Comments and Response Report

The Proposed Housing Development on Portions 91 of the Farm Matjes Fontein 304, Plettenberg Bay, Western Cape.

DEA&DP Ref. No: 16/3/3/1/D1/13/0001/25

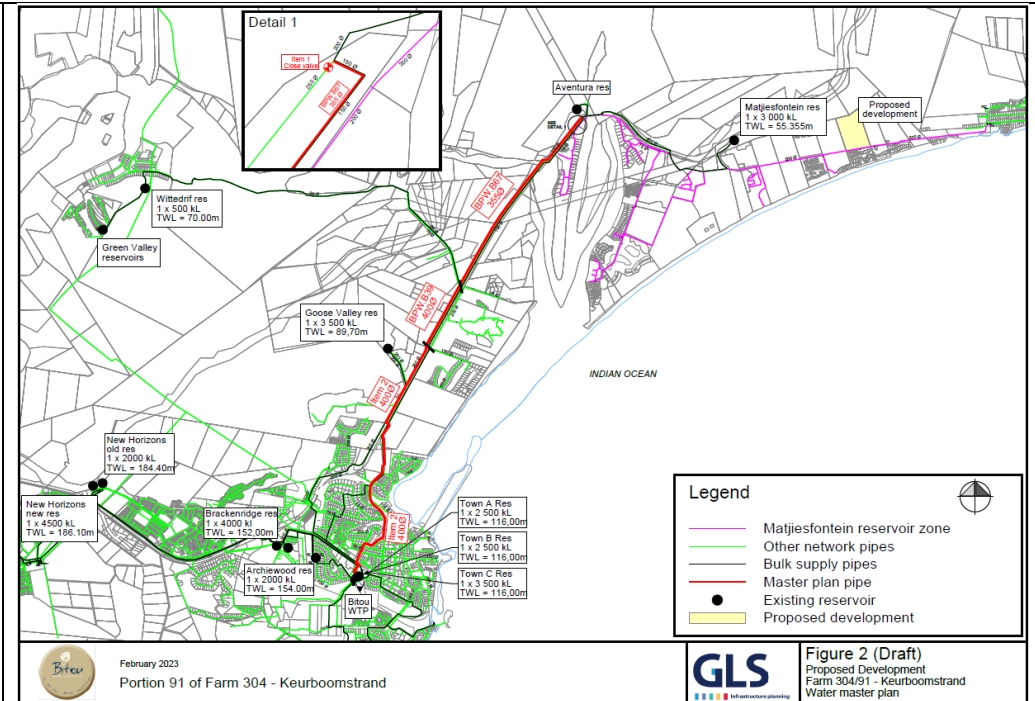
Roughly 5,5 km of the existing 7,7 km x 150 mm Ø bulk pipeline between the Town reservoirs and the Keurbooms River should be upgraded in order to supply the Matjiesfontein reservoir from the Town reservoirs under gravity (no augmentation of bulk supply from the Goose Valley reservoir will then be required).

The GLS report states that the Matjiesfontein reservoir capacity and the capacity of the supply pipes from the reservoir to the development is adequate to accommodate the development. However, the pipes supplying the Matjiesfontein reservoir from the Town reservoirs require to be upgraded. These upgrading relate to both replacement of an unserviceable existing pipe and increasing size to accommodate masterplanning for future developments. The Portion 91 Matjiesfontein development water demand represents a very small proportion of overall capacity to be improved by the upgrades.

Fig. 10: Topographical cross-sectional plans A to A' as per Fig.9 . Beacon Survey June 2024 and VPM Survey 2023.

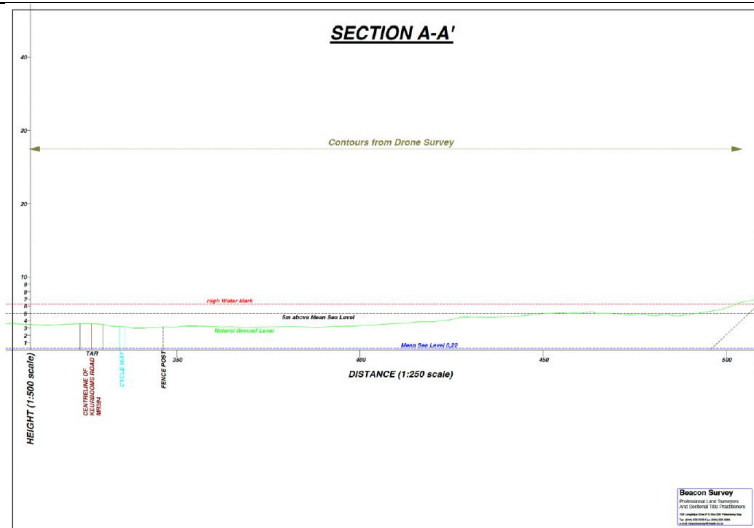
All of the above mentioned sites ie 1), 2) and 3), are situated in the Keurbooms-Bitou Estuarine Functional Zone, a flood plain, which is less than 5m above mean sea level

Fig.12: Keurbooms Estuary: Estuarine Management Plan showing 1 in 50 and 1 in 100 flood lines.

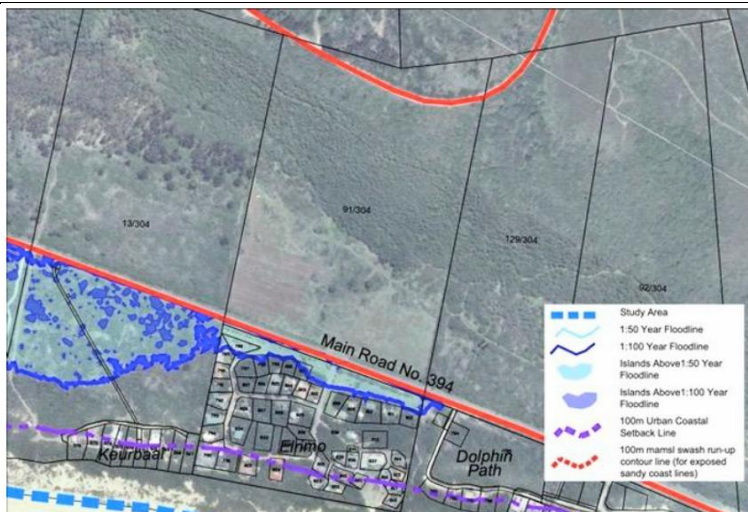
I would strongly agree that the 1 in 100 year flood line, should therefore be reviewed, as per the recommendations of the Garden Route District Climate Change Adaptation Response Implementation Plan (2024).

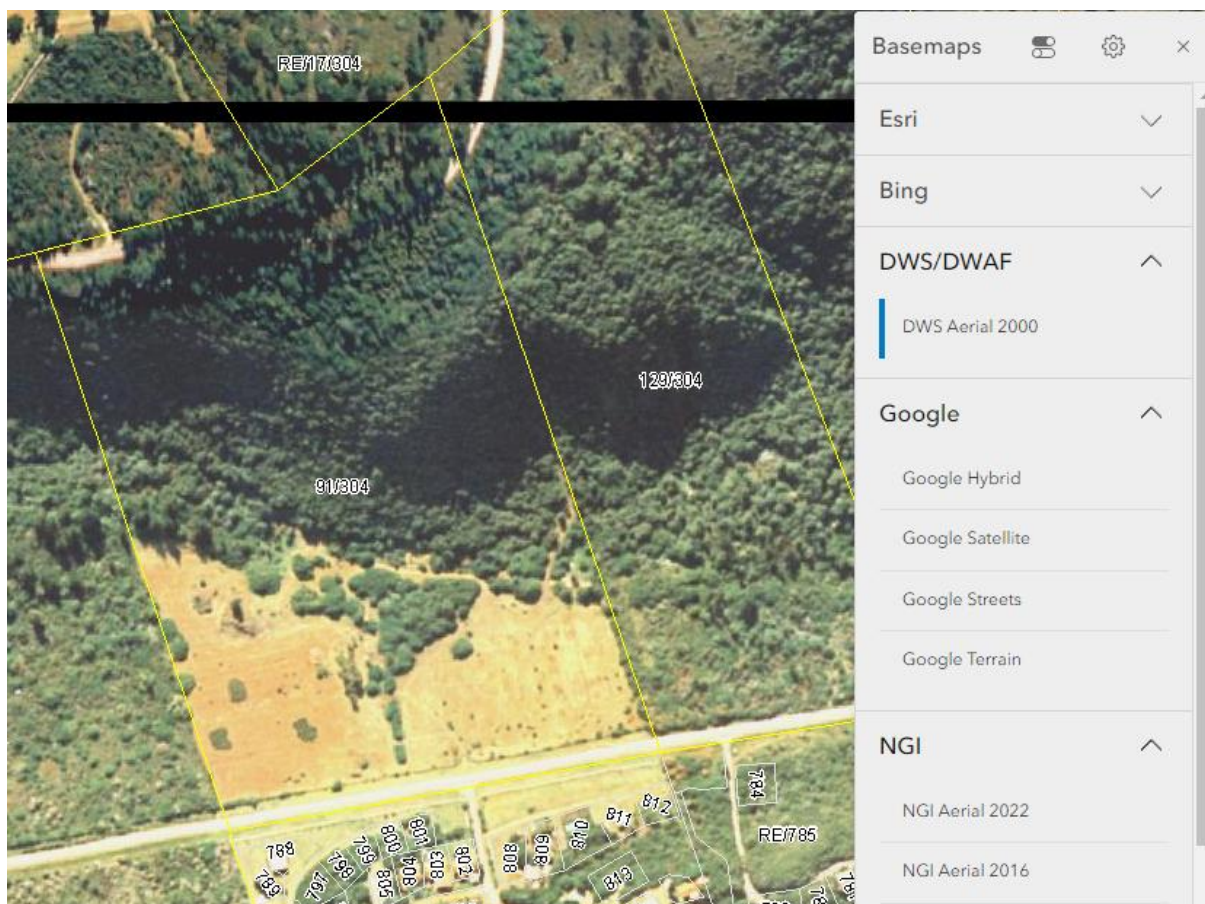
The urban edge in this area has been defined by the steep sloped to the north and the 5m contour line which defines the Estuarine Functional Zone to the south.

The reason why the proposed development area extends beyond the identified urban edge is because the Aquatic Assessment confirmed that the area contains no estuarine habitats and is outside of the 1:100-year flood line of the estuary and is thus not part of the estuarine functional zone and for this reason the 4,5 or 5m contour line has not been observed. The steep slopes and forest vegetation to the north has however been identified as sensitive and have been protected with a 20m buffer strip.
